SUBJECT: ISSUANCE OF AMENDMENT NOS. 191 , 191 AND 188 TO FACILITY OPERATING LICENSES DPR-38, DPR-47 AND DPR-55 - OCONEE NUCLEAR STATION, UNITS 1, 2 AND 3 (TACS 80378/80379/80380)

The amendments modify specifications having cycle-specific parameter limits by transferring these limits to a Core Operating Limits Report (COLR). In addition, the specified height of the active fuel assembly is revised to incorporate a new fuel design.

AMENDMENT TO FACILITY OPERATING LICENSE

ATTACHMENT TO LICENSE AMENDMENT NO. 191

Figure 2.1-1

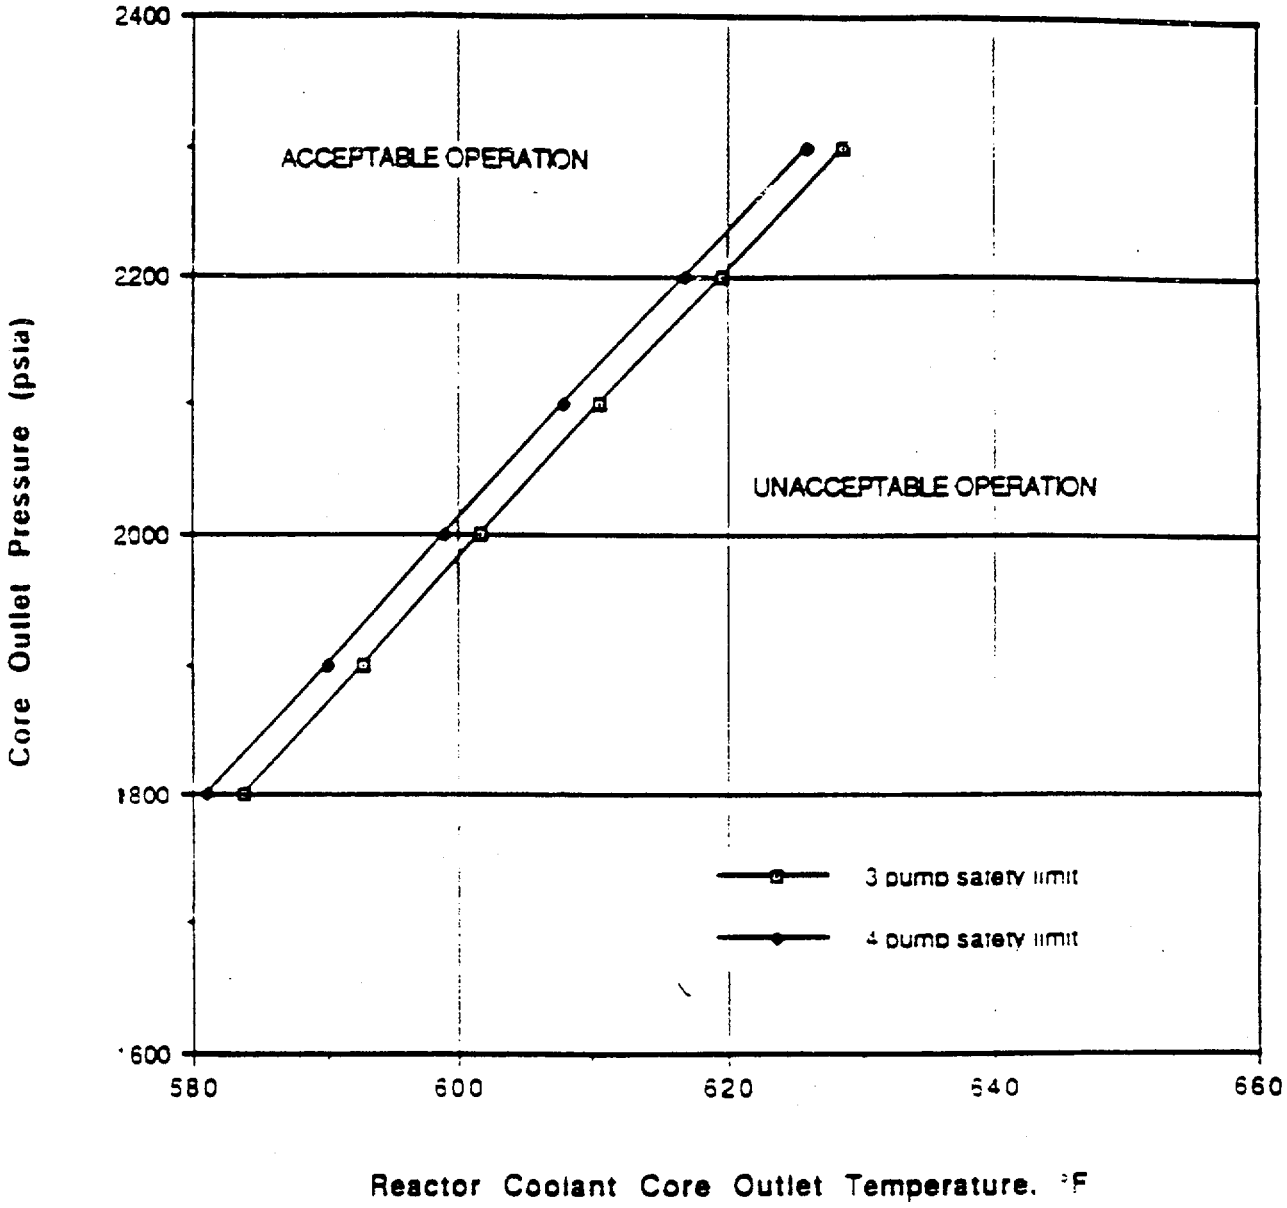
The curve presented in Figure 2.1-1 represents the conditions at which the minimum allowable DNBR is predicted to occur for the limiting combination of thermal power and number of operating reactor coolant pumps. This curve is based upon the design nuclear peaking factors provided in the Core Operating Limits Report.

Figure 2.1-2

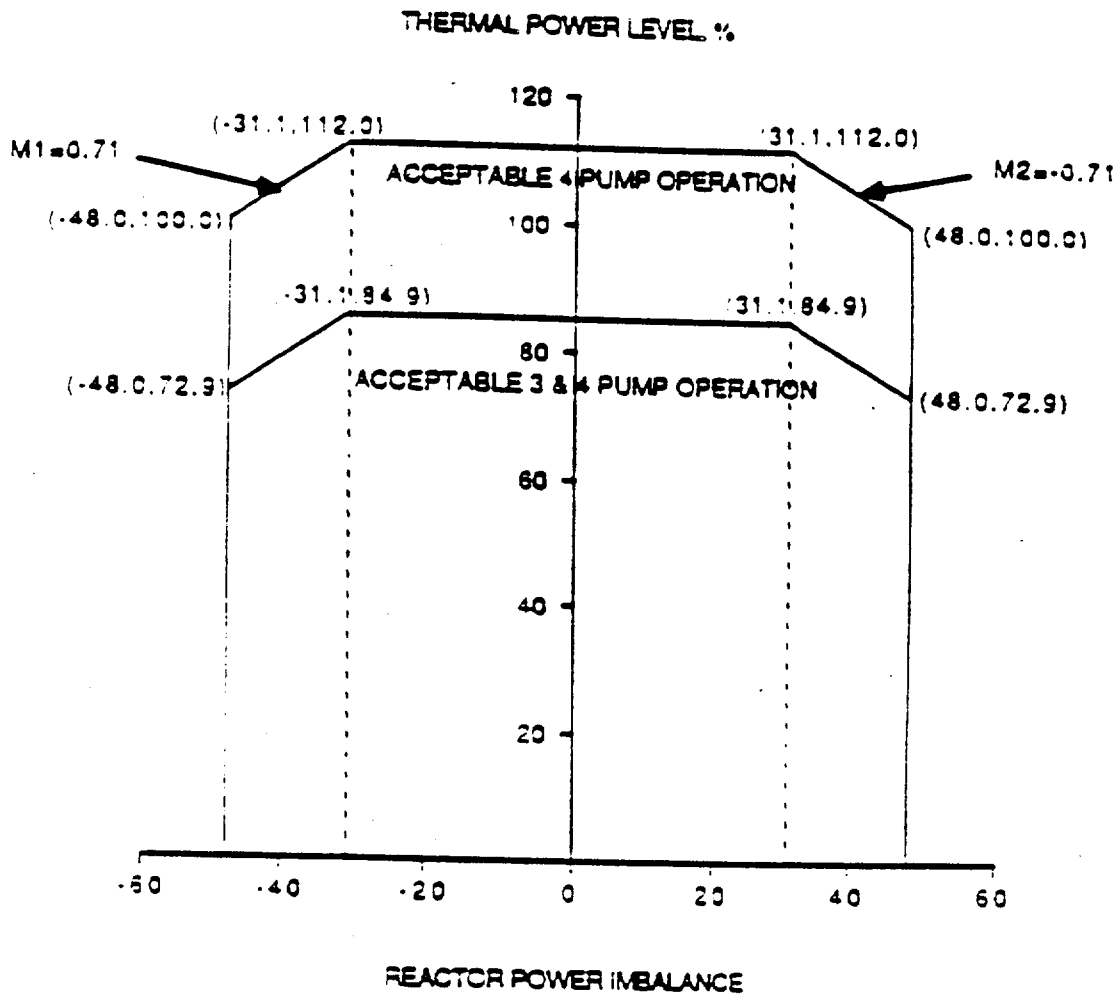
The maximum local fuel pin centerline temperature shall be less than 5080 - $(6.5 \times 10^{-3}) \times$(Burnup, MWD/MTU) $^{\circ}$F. Operation within this limit is assured by compliance with the Axial Power Imbalance Protective Limits as specified in Figure 2.1-2.

The DNBR shall be maintained greater than the correlation limits of 1.3 for BAW-2 and 1.18 for BWC. Operation within this limit is assured by compliance with the Axial Power Imbalance Protective Limits and variable low RCS pressure limits as specified in Figures 2.1-2 and 2.1-1 respectively.

The core protection safety limits are based on an RCS flow less than or equal to 385,440 gpm (4 pump operation). Three pump operation is analyzed assuming 74.7 percent of four pump flow. The maximum thermal power for three pump operation is provided in Figure 2.1-2.
